TSG-RAN Working Group 1(Radio) meeting #3
Nynäshamn, Sweden 22-26, March 1999

*TSGR1#3(99) 202*

**Title:**     **Text Proposal for Optimisation of extended TFCI encoding**

# Text Proposal for S1.12 and S1.22 (FDD and TDD multiplexing, channel coding and interleaving description)

**~~Figure 7-19. Mapping of TFCI bits to two words~~**

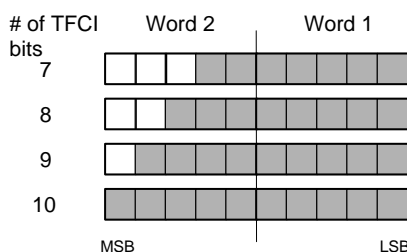
If the number of TFCI bits is 7-10 the TFCI information field is split into two words of length 5 bits as shown in the <u>following formula:</u> ~~Figure 7-19.~~

$n := \left\lfloor \sqrt{TFCI} \right\rfloor$; n is the largest integer being smaller than or equal to the square root of the transmitted TFCI value.

if $TFCI < n^2 + n$

then $Word1 := n$; $Word2 := TFCI - n^2$

else $Word2 := n$; $Word1 := n^2 + 2n - TFCI$
